Docket: NRC-2009-0337

Combined License Application for Turkey Point Nuclear Plant, Unit Nos. 6 and 7; Draft Environmental Impact Statement

Turkey Point Nuclear Power Plant Units 6 and 7:

Expansion Assessment

Figure 4. Reclassified and Bicolored Digital Elevation Map of Turkey Point Nuclear Power Plant. The proposed construction site is less than three feet above sea-level and adjacent to Biscayne Bay, seen here in grey.

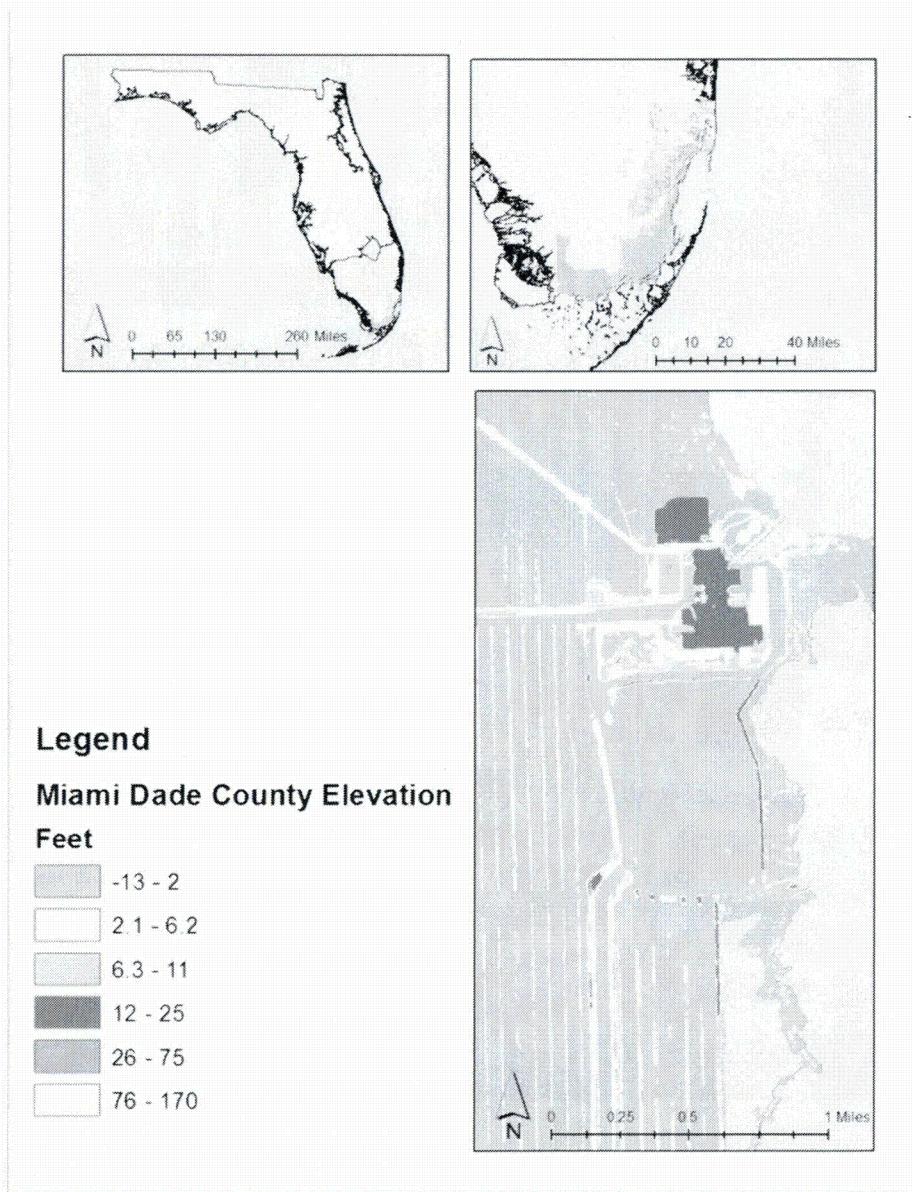
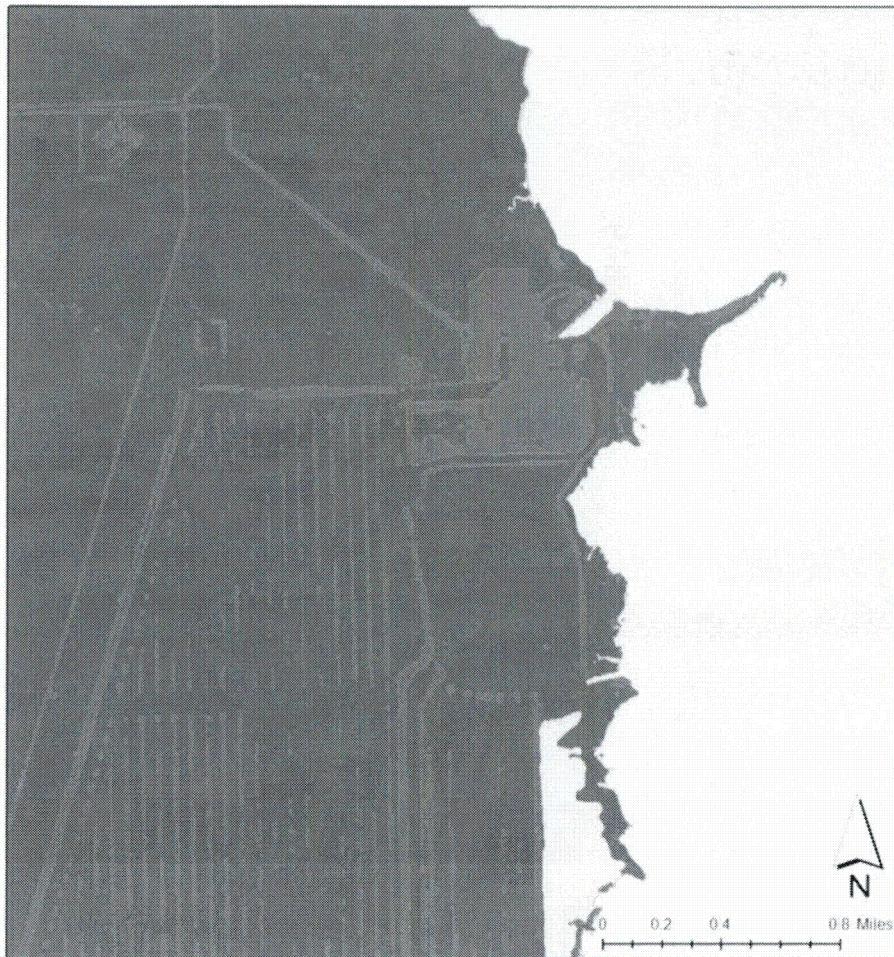
The GIS maps created (**Figures 3-5**) show that the construction area is below three feet of elevation. Units 6 and 7 would also be built within the demarcated habitat of the threatened American Crocodile. However, more information is needed to quantify and describe the particular impact the expansion and operation of the plant would have on the species.
